Access Compliance Report

Public Rights-of-Way

Intersection ID: N/A	Main Street: WOODLAWN_RD	Cross Street: N/A	Location: SE
ADA ID: DD4B34C3F609	Ramp Type: PerpDiag	Initial Pass/Fail: Fail	Overall Compliance: No
		Severity Score: 25

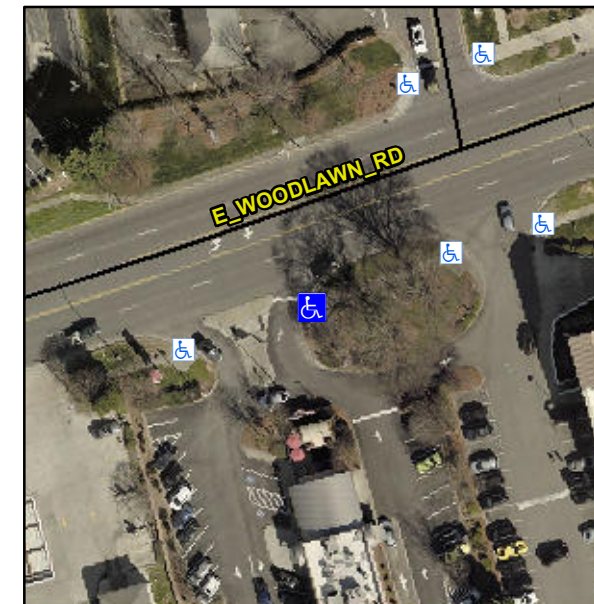
Not Found, R304.5.3

Compliance	Description	Data	Compliance	Description	Data
N/A	Ramp Length (in)	78.0	Yes	Ramp Slope (%)	5.6
Yes	Ramp Width (in)	74.0	No	Ramp XSlope (%)	10.5
N/A	Flare Type LT	N/A	N/A	Flare Type RT	N/A
N/A	Flare Slope LT (%)	N/A	N/A	Flare Slope RT (%)	N/A
N/A	Flare Traversable LT?	N/A	N/A	Flare Traversable RT?	N/A
N/A	Landing Length (in)	N/A	N/A	DWS Provided?	N/A
N/A	Landing Width (in)	N/A	N/A	DWS Contrast?	N/A
N/A	Landing Slope (%)	N/A	N/A	DWS Length (in)	N/A
N/A	Landing X Slope (%)	N/A	N/A	DWS Full Width?	N/A
N/A	Landing Curb? (Y/N)	N/A	N/A	DWS Offset (in)	N/A
N/A	Shared Landing?	N/A			
N/A	Gutter Ponding?	N/A	N/A	Gutter Slope (%)	N/A
N/A	Gutter Lip Ht (in)	N/A	N/A	Gutter X Slope (%)	N/A
N/A	Painted X Walk1?	No	N/A	Painted X Walk2?	No
	X Walk 1 Direction	To N		X Walk 2 Direction	To W
N/A	X Walk 1 Width (in)	N/A	N/A	X Walk 2 Width (in)	N/A
	X Walk 1 Slope (%)	4.4		X Walk 2 Slope (%)	9.1
	X Walk 1 X Slope (%)	8.9		X Walk 2 X Slope (%)	6.6

Remove & Replace Curb Ramp With Two New Directional Ramps or Equivalent.
